Amendments to the Drawings:

REMARKS

FIG. 13
(Prior art)

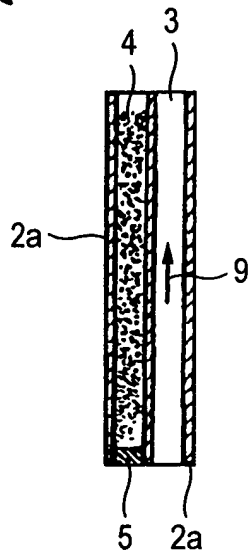
The Examiner objected to Figures 13-15 because they needed to be labeled with "Prior Art". Figures 13-15 have been appropriately amended.

The sheet of drawings attached in the Appendix includes changes to Figs. 13-15. This sheet replaces the original sheet. The drawings have been changed as follows: The legend "Prior Art" has been added.
